Collective amendments - UN Regulations Nos. 3, 7, 23, 45, 87, 98, 112, 113 and 123

Proposal for Collective Amendments to Regulations Nos. 3, 7, 23, 45, 87, 98, 112, 113 and 123

Submitted by the expert from the Working Party "Brussels 1952"*

Annex 3

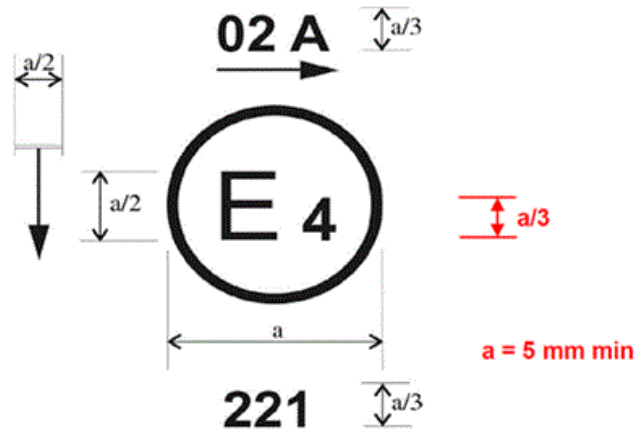
Annex 3, amend to read:

The number mentioned close to the symbol "A" indicates that approval was granted in accordance with the requirements of Regulation No. 7 as amended by the 02 series of amendments. The horizontal arrow indicates the side on which the required photometric specifications are met up to an angle of 80° H. The vertical arrow starting from a horizontal segment and directed downwards indicates a permissible mounting height of equal to or less than 750 mm from the ground for this device."

- (b) All devices except for lighting devices: $a \geq 5$ mm
- (c) In Regulation No. 7, the dimension "a" has inadvertently been omitted following earlier amendments. It is necessary to provide it again.

Figure 1
Marking for single lamps

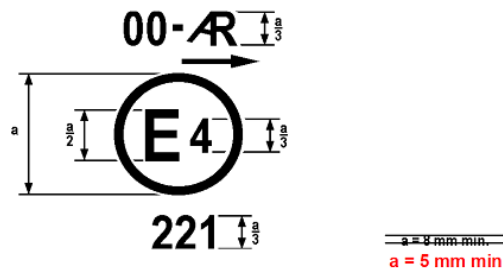
Annex 2, Figure 1, amend to read:

- (a) Lighting devices except for reversing lamp: $a \geq 8 \text{ mm}$ (on glass), $a \geq 5 \text{ mm}$ (on plastic material)

Annex 3
Arrangements of the approval marks

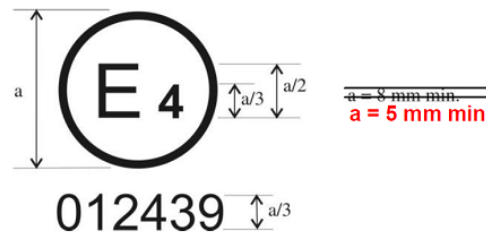
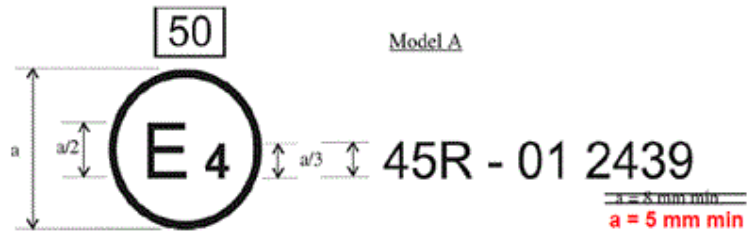
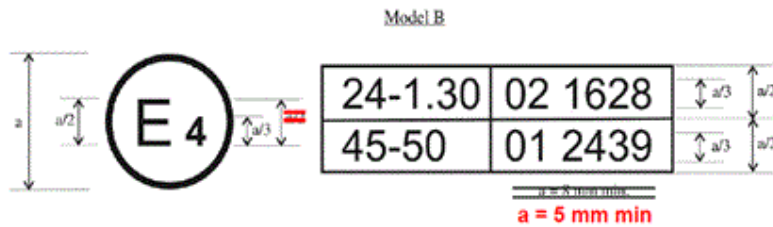
Annex 3, Figures 1 and 2, amend to read:

Annex 2
EXAMPLES OF ARRANGEMENTS OF APPROVAL MARKS

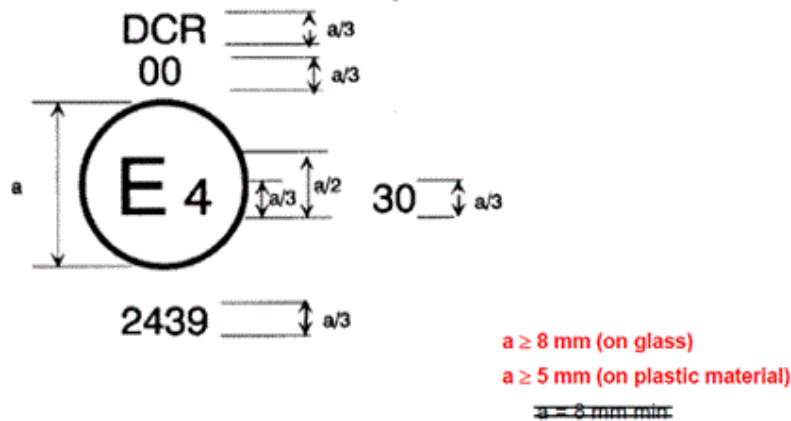
Annex 2., amend to read:

Annex 2
EXAMPLES OF ARRANGEMENT OF APPROVAL MARKS

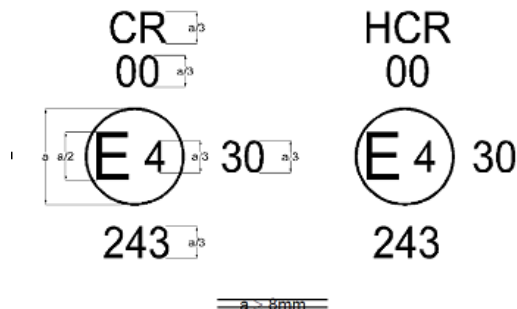
Annex 2., amend to read:

Figure 1 **a ≥ 8 mm (on glass)** Figure 2
a ≥ 5 mm (on plastic material)

Examples of arrangement of approval marks

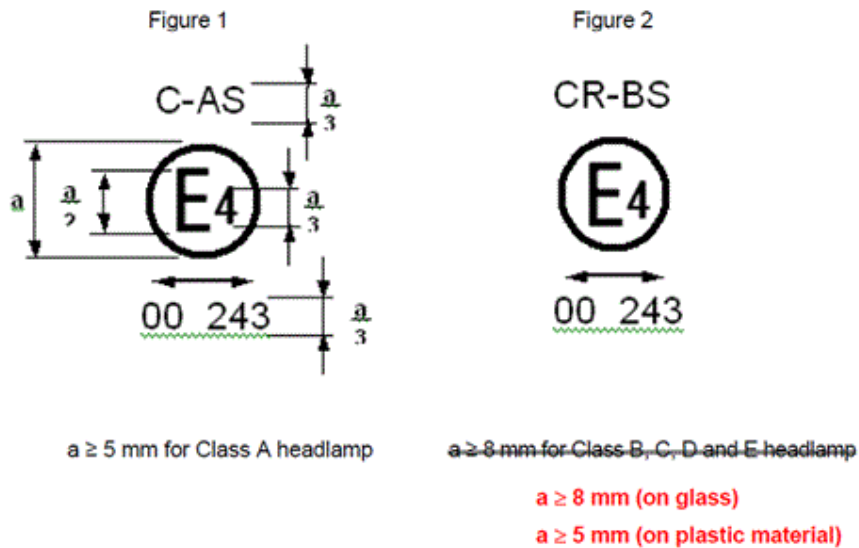
Annex 2., amend to read:

EXAMPLES OF ARRANGEMENTS OF APPROVAL MARKS

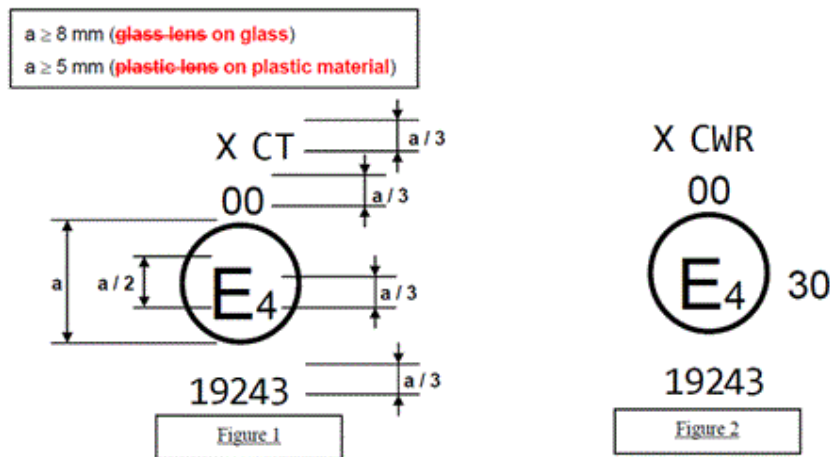
Annex 2., amend to read:
